**City of Portland, Maine – Building or Use Permit Application** 389 Congress Street, 04101, Tel: (207) 874-8703, FAX: 874-8716

Location of Construction: <b>19 Commercial Street</b>		Owner: <b>Clay Cove Corp./Stevan McDuffie</b>	Phone: <b>773-7206</b>	Permit No: <b>990745</b>
Owner Address:	Lessee/Buyer's Name: <b>** BIW Five County Credit Union</b>	Phone:	BusinessName:	<div style="border: 2px solid black; padding: 5px; text-align: center;"> <b>PERMIT ISSUED</b>  <b>JUL 14 1999</b> </div>
Contractor Name: <b>Sign Solutions</b>	Address:	Phone:		
Past Use: <b>Credit Union</b>	Proposed Use: <b>Same</b>	<b>COST OF WORK:</b> \$ <b>0</b>	<b>PERMIT FEE:</b> \$ <b>44.20</b>	<div style="border: 2px solid black; padding: 5px;"> <b>CITY OF PORTLAND</b> </div>
		<b>FIRE DEPT.</b> <input type="checkbox"/> Approved <input type="checkbox"/> Denied	<b>INSPECTION:</b> <i>Sign</i> Use Group: Type:	
		Signature:	Signature: <i>[Signature]</i>	
Proposed Project Description: <b>Erect two 8 x 12 Signs.</b>		<b>PEDESTRIAN ACTIVITIES DISTRICT (P.A.D.)</b>		Zone: <b>R-3</b> CBL: <b>029-P-032</b>

ADDRESS: 19 Commercial St.  
 PERMIT APPLICATION FOR: Bank Five County Credit Union  
 BUILDING OWNER: Steve Mc

<p><b>SOLUTIONS</b></p>	
REVISOR	1
APPROVED	
DATE	5/11/99
DWG NO.	1
DESIGNER	SCOTT EHRIG
CLIENT	BIW Five County FCU
LOCATION	Topsham, ME

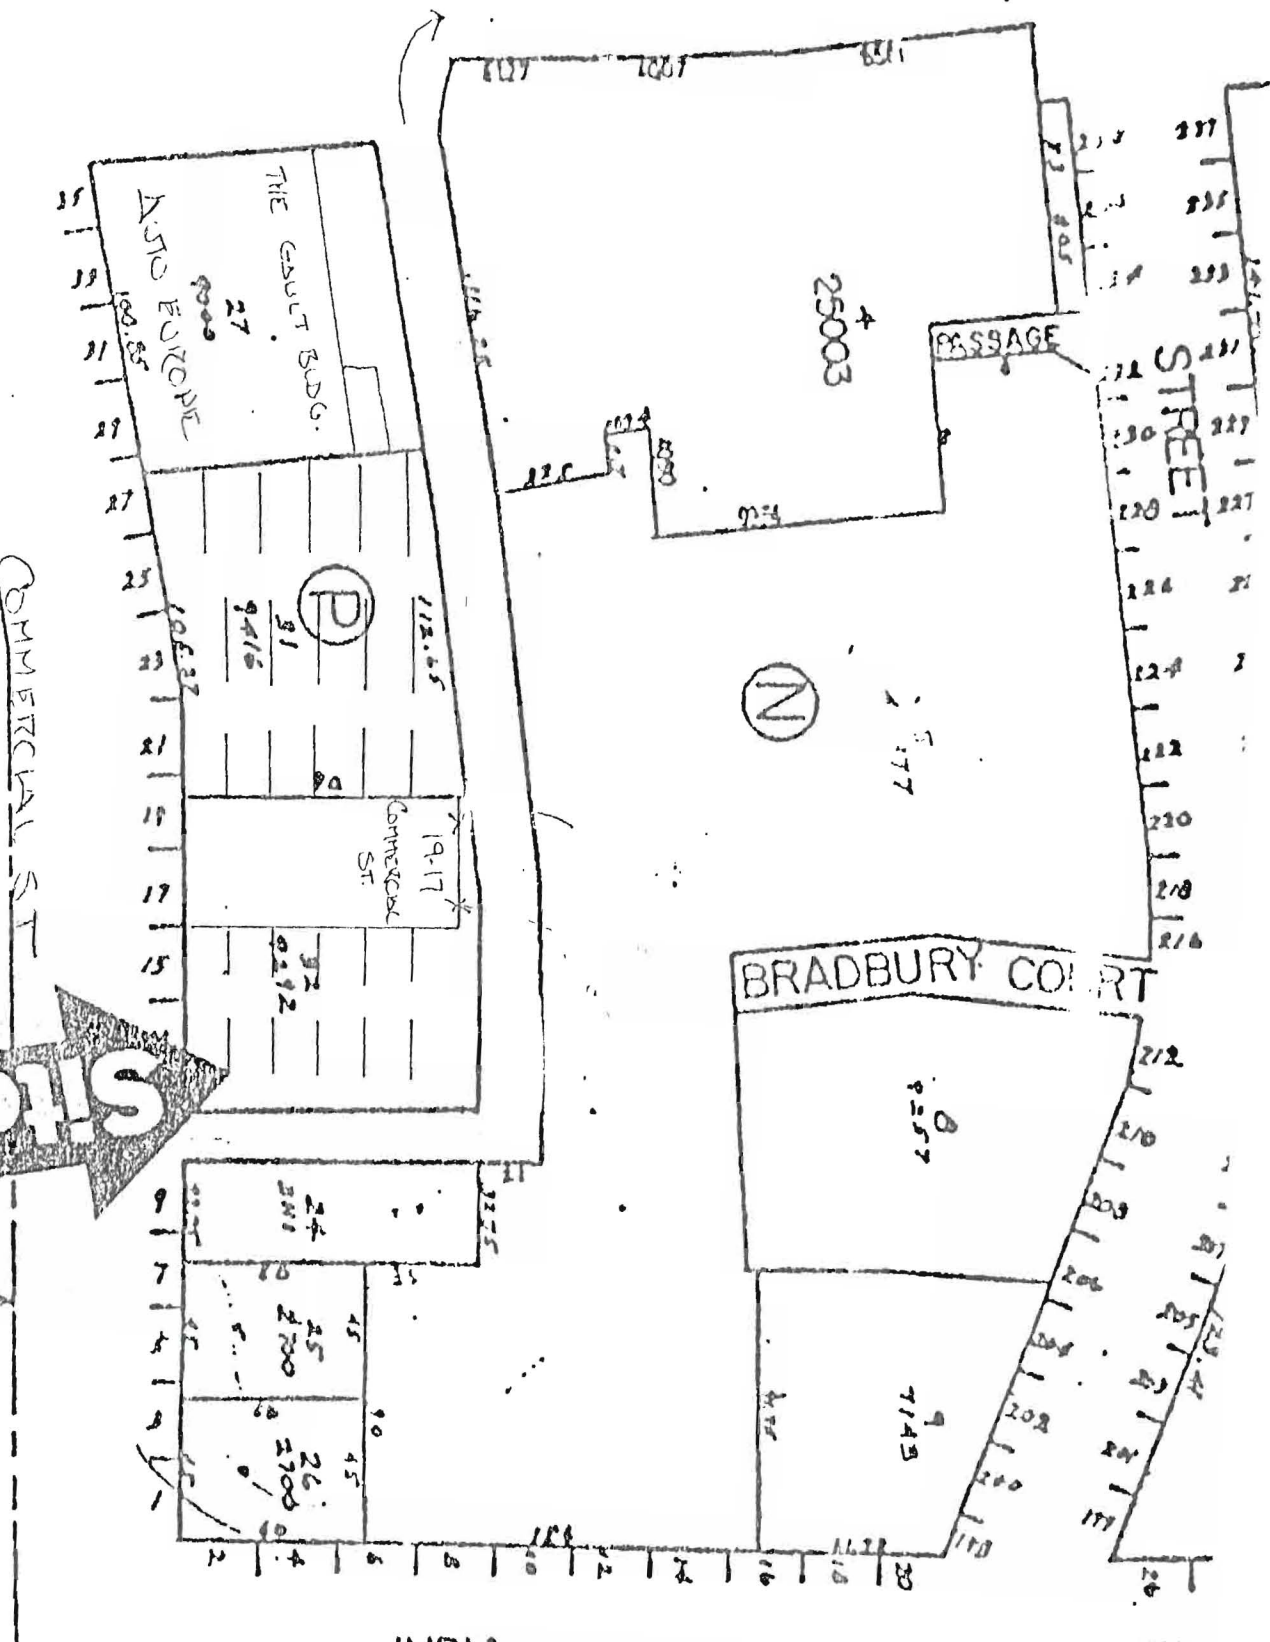
Contact Historic Preservation Staff ( 874-8726 or 874-8728) prior to installation of sign(s) to confirm approved location.

1. That sign letters be attached into mortar joints, avoiding drilling into brick, as per Historic Preservation approval.
2. \_\_\_\_\_
3. \_\_\_\_\_

*approved as shown  
 if these are OK  
 Scott Ehrig  
 6/21/99*
